MFN 06-274

Subject: Response to RAI Letter Number 20 Related to ESBWR Design Certification Application – Seismic Design – RAI Numbers 3.7-16, 3.7-24, 3.7-27, 3.7-30, 3.7-32, 3.7-33, 3.7-35, 3.7-37, 3.7-38, 3.7-39, 3.7-50, 3.7-54 and 3.7-57

**Response to NRC RAI Letter No. 20 Related to ESBWR Design
Certification Application**

**RAI Numbers 3.7-16, 3.7-24, 3.7-27, 3.7-30, 3.7-32, 3.7-33,
3.7-35, 3.7-37, 3.7-38, 3.7-39, 3.7-50, 3.7-54, and 3.7-57**

Figure 3.7-37 (1) Frequency-Dependent vs. Frequency-Independent Soil Spring for RB/FB at Soft Site

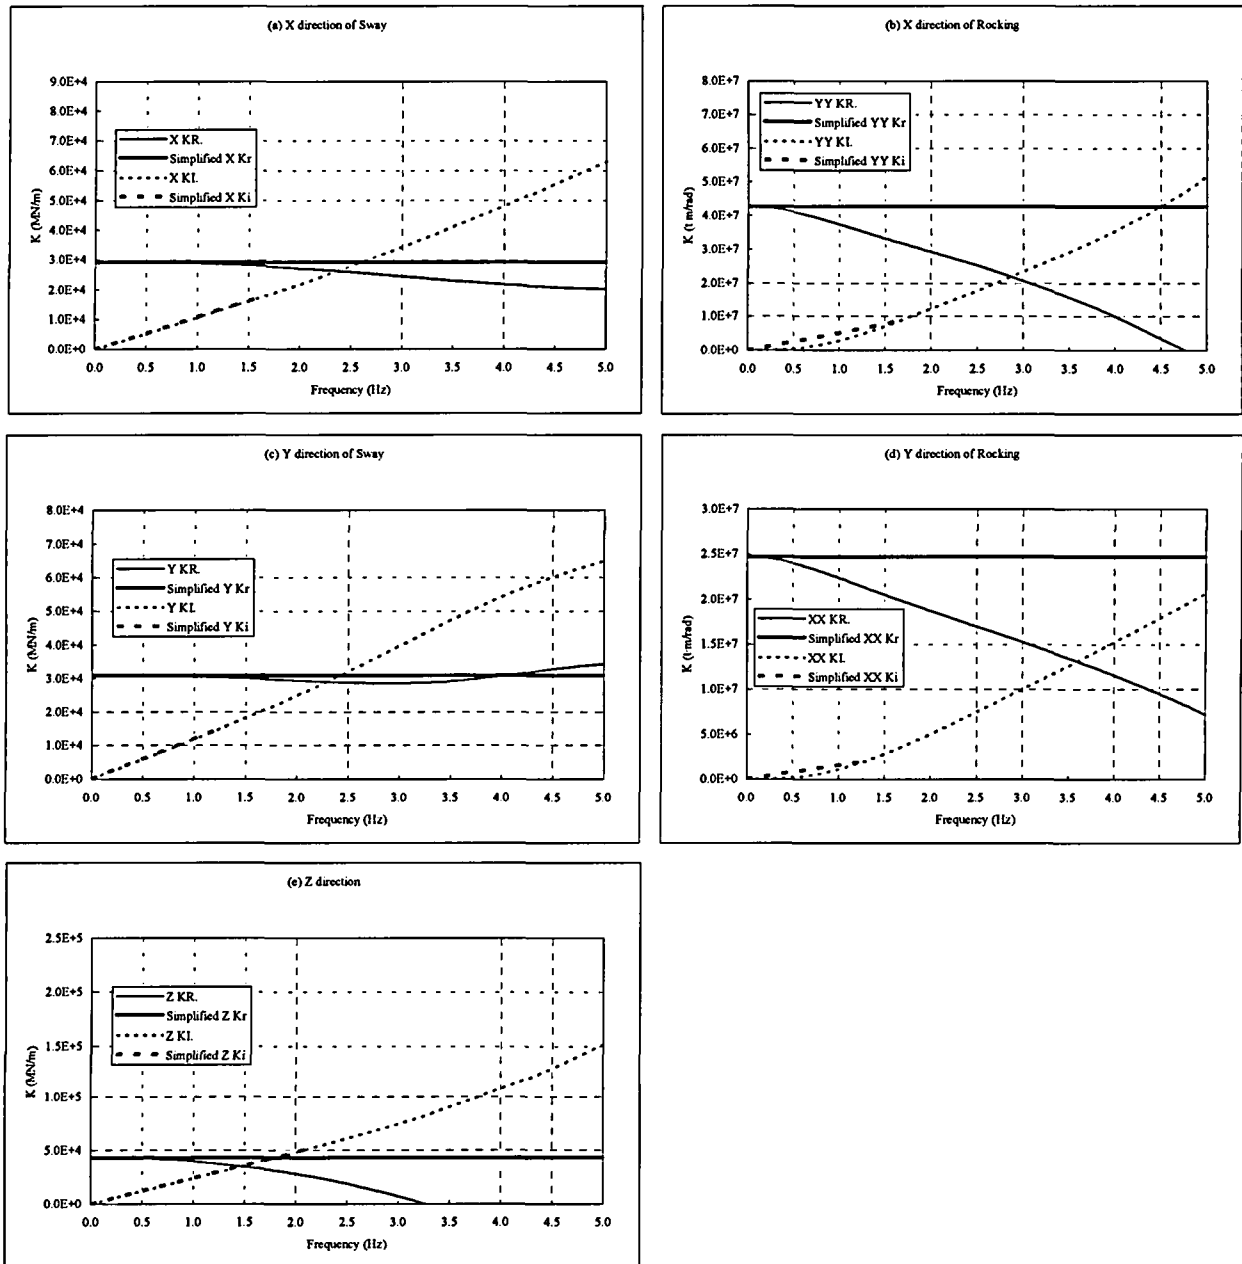
In the third paragraph of DCD Appendix 3A, Section 3A.5, the applicant discussed how to use the frequency-independent soil-spring K_c and damping coefficient C_c to represent the soil foundation in the SSI analysis of the RB/FB and CB. DCD Tables 3A.5-1 and 3A.2 provide tabulated numerical values of K_c and C_c for the RB/FB and CB. However, the applicant did not describe in the DCD how the frequency-dependent soil-springs (real and imaginary parts of the soil stiffness) were calculated, and how these frequency-dependent soil-springs were converted to frequency-independent soil-springs and damping ratios. The staff requests the applicant provide a detailed description in the DCD.

The detailed description for the calculation of the frequency-dependent soil-springs (real and imaginary parts of the soil impedance) was provided in the response to RAI 3.7-49, in which the procedure used to convert these frequency-dependent soil impedance to frequency-independent soil stiffness and damping ratio was also described. An illustrative example for comparison of the calculated frequency-dependent impedance with the equivalent frequency-independent soil stiffness and damping is shown in Figure 3.7-37 (1) for the soft site.

DCD Section 3A.5 will be revised in the next update as noted in the attached mark-up to provide a detailed description.

Figure 7.2-1 Floor Response Spectra - RBF Basemat X

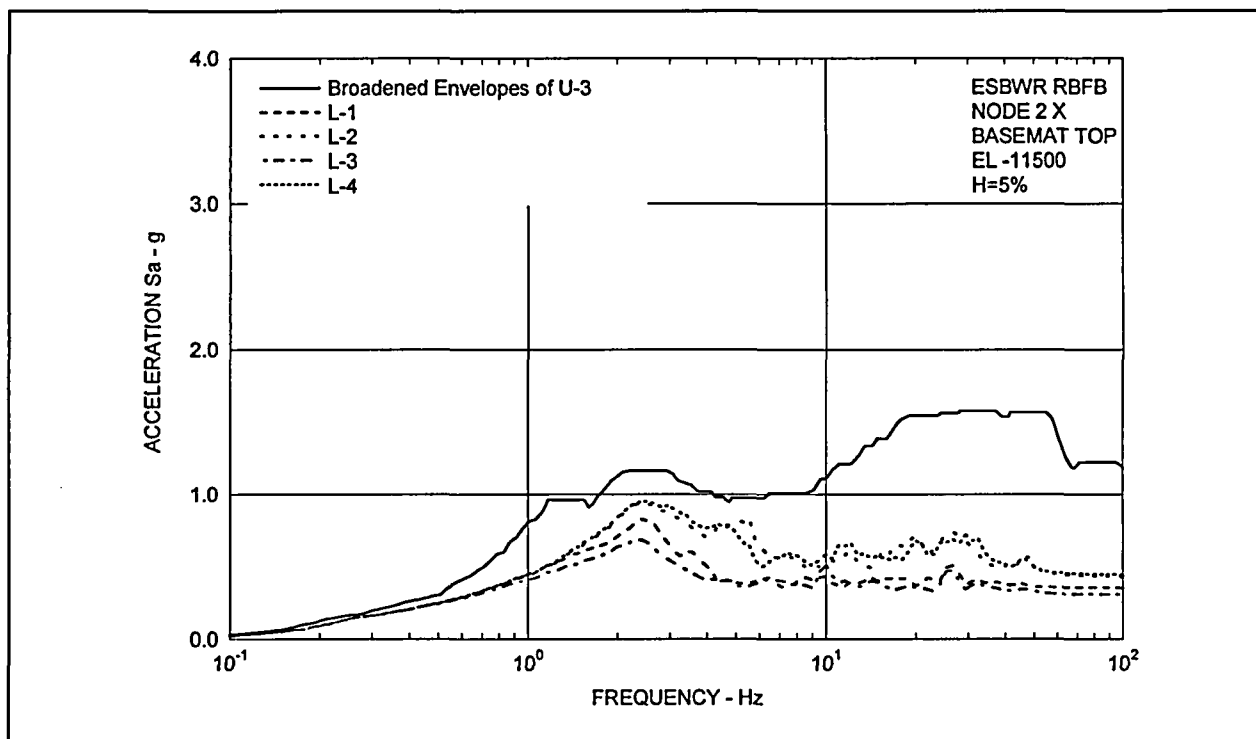
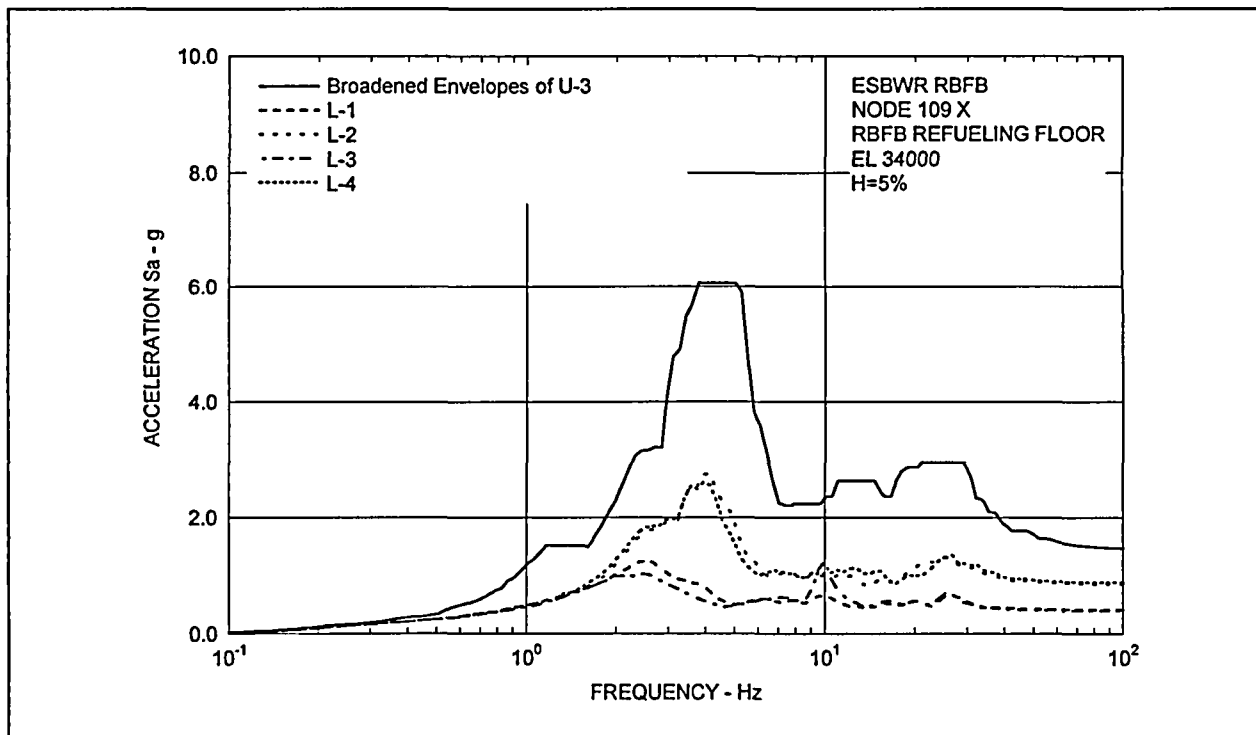
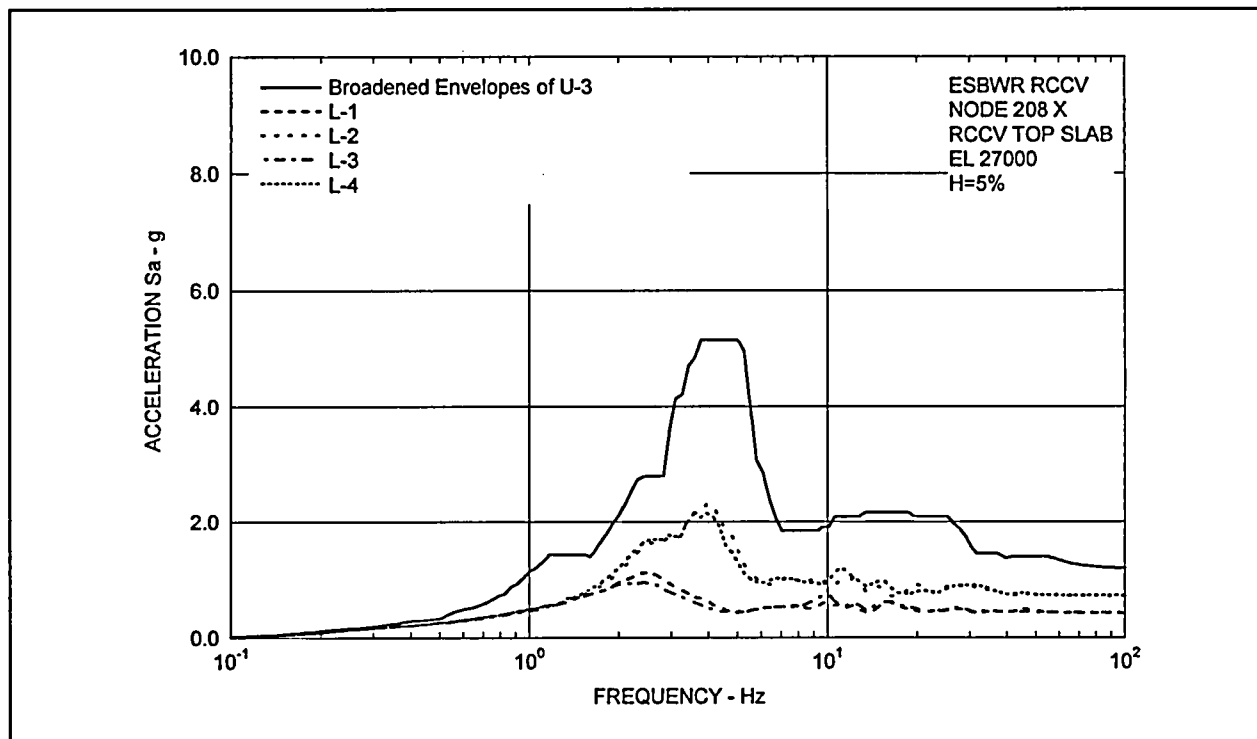
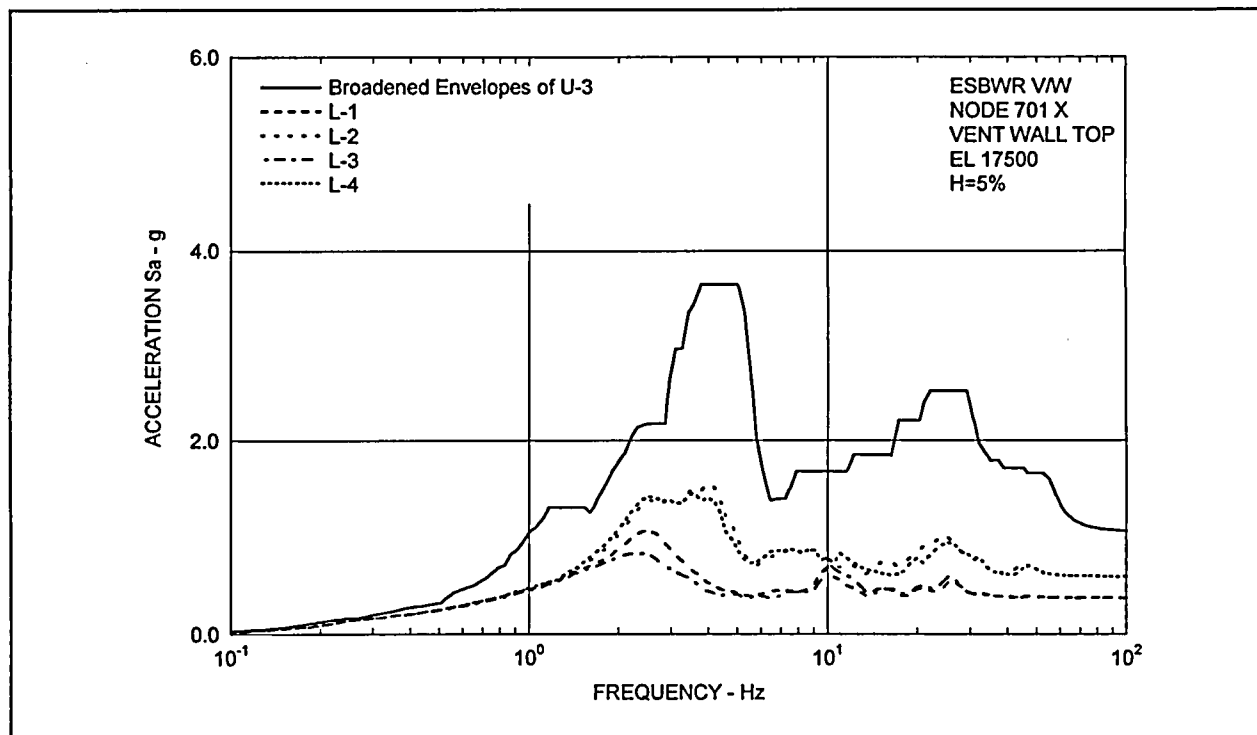
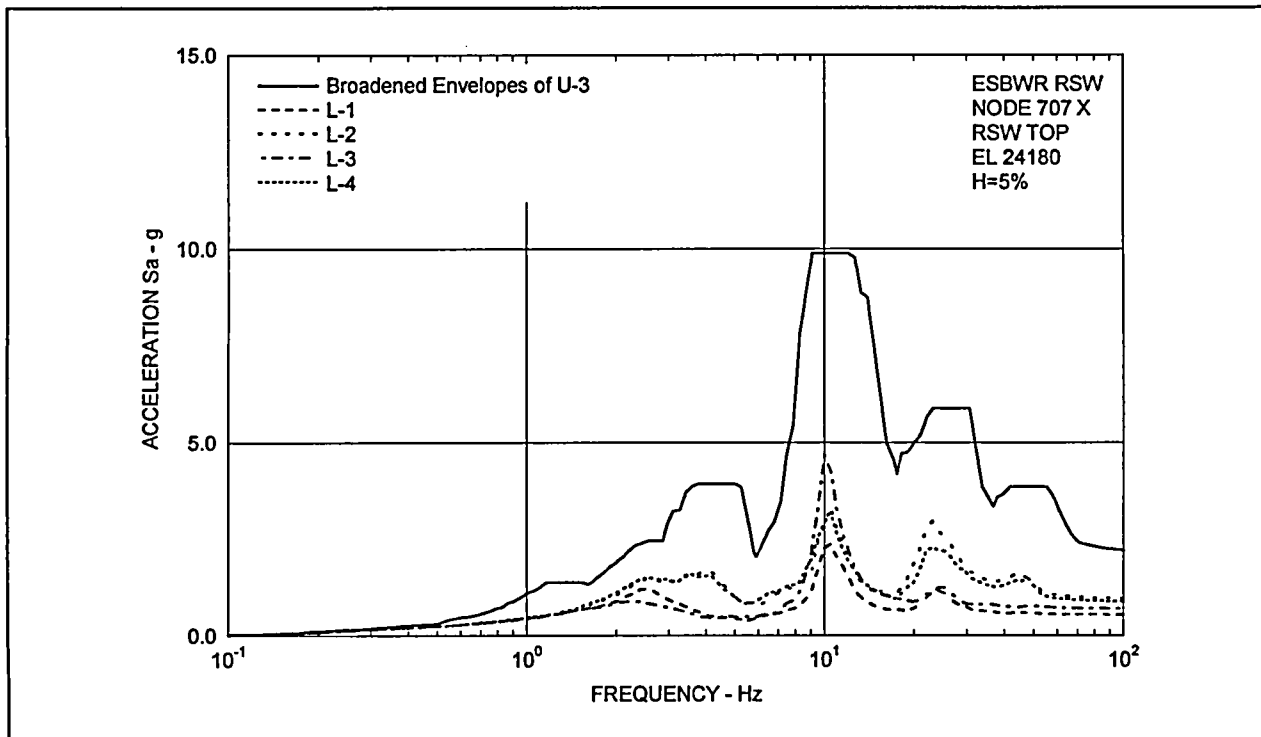
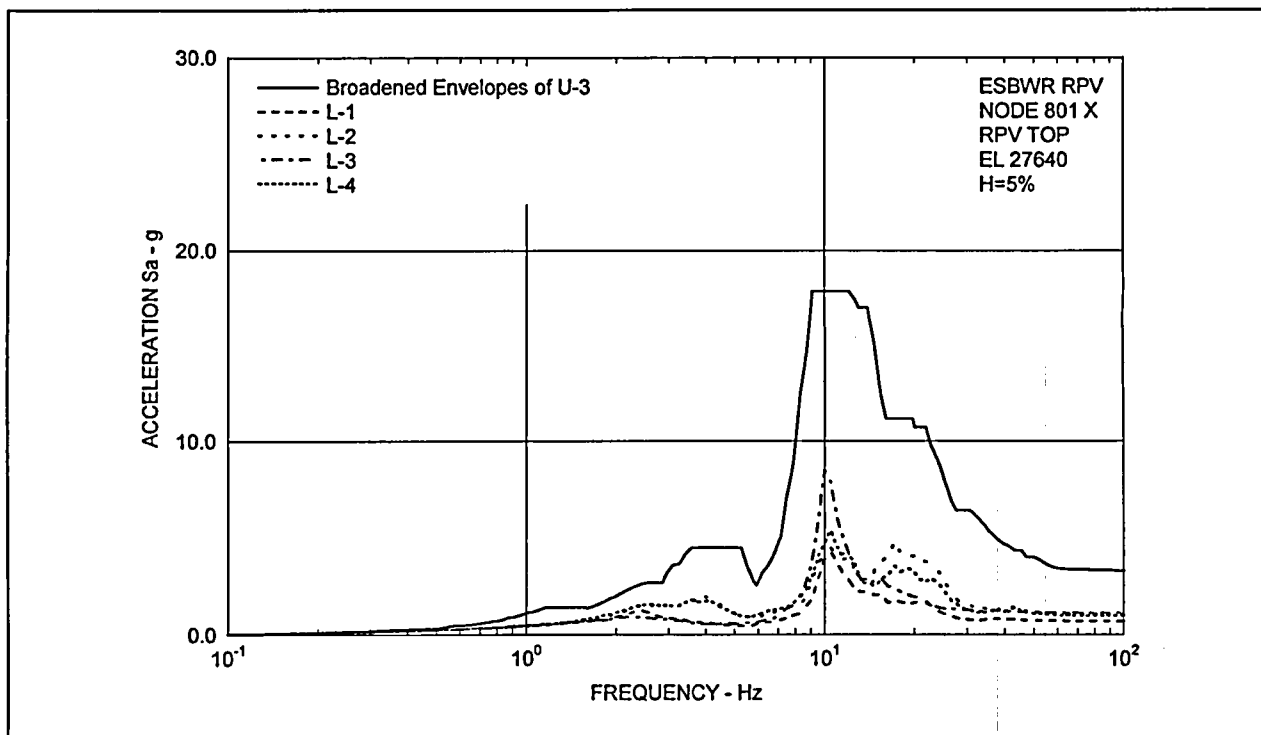
The last part of the second paragraph on page 3A-4 of DCD Section 3A.3.1 states that three subsurface conditions (soft, medium, rock and hard rock sites) are considered to be uniform half-space, as provided in Table 3A.3-1 for SSI analyses. According to the staff's review experience, there are a number of sites composed of layered materials that should be considered for siting of nuclear plants. Such sites may have significant variation of shear wave velocity with depth, leading to potentially significant impedance mismatches between layers. Such profiles can have effective impedance functions that are significantly different from those associated with a uniform half-space. (See for example, "Handbook of Impedance Functions" by Sieffert and Cevaer). These sites are typically characterized by impedance functions that are highly frequency-dependent, particularly those associated with radiation damping. The approach of using a frequency-independent assumption for both stiffness and damping in SSI may lead to significantly different computed responses. The behavior (or response) of a massive structure (such as RB/FB or CB) may be significantly influenced by these variations due to site conditions. For the design of a standard plant such as ESBWR, the DCD should address the limitations on site layering that will be required, to ensure the applicability of the ESBWR design, which is based on the assumption of uniformity. The staff requests the applicant to include this information in the DCD, and also identify it as a COL interface item.

Comparisons of floor response spectra (FRS) (5% damping) at selected RBFB locations are shown in Figures 7.2-1 through 7.2-18. Similarly, FRS (5% damping) at selected CB locations are compared in Figures 7.2-19 through 7.2-21.

It is found from the results that the responses for the layered site cases are bounded by the broadened envelope responses of uniform site cases in the whole frequency range.

As stated in Section 7.1, the existing DCD design load will be updated to incorporate the responses due to the single envelope input motion at the uniform sites. The revised DCD design load has no impact from the response results for the layered sites.
